BAKERSFIELD CITY SCHOOL DISTRICT

Re: Project #22244.00-73-MD: Installation of concrete masonry walls, iron fencing and operable access gates at the perimeter of the District's Maintenance and Transportation yard

ADDENDUM 4:

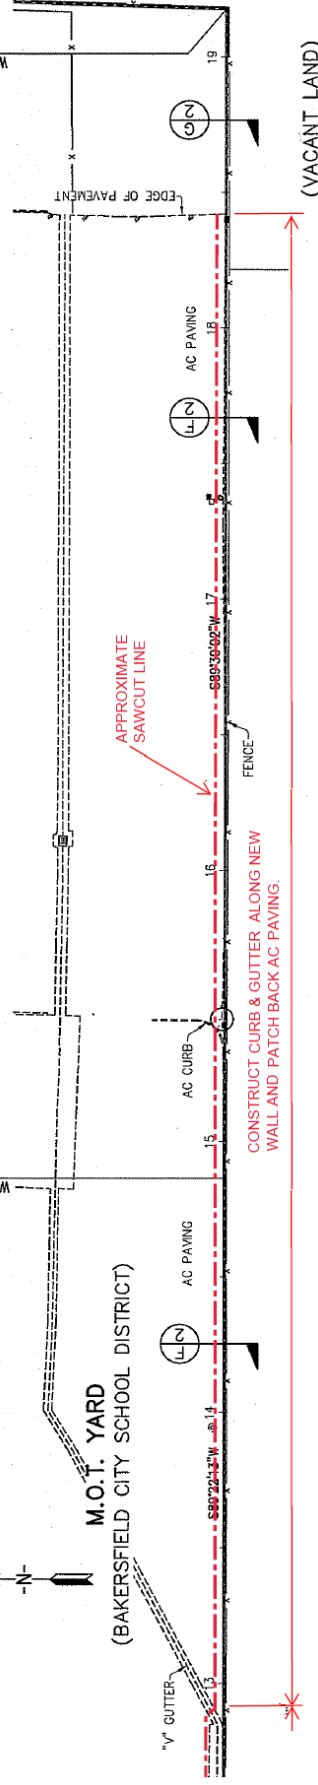
1. Refer to addenda 3; item 6. Intent is to add new curb and gutter per previously issued addenda all along the entire south side of southern yard where pavement occurs. See attached drawing for clarification.
2. Refer to drawings; sheet 3, west fencing area south of main admin building. Add weep holes as noted on attached drawing for locations.

CONSTRUCT CURB & GUTTER ALONG NEW
WALL AND PATCH BACK AC PAVING.
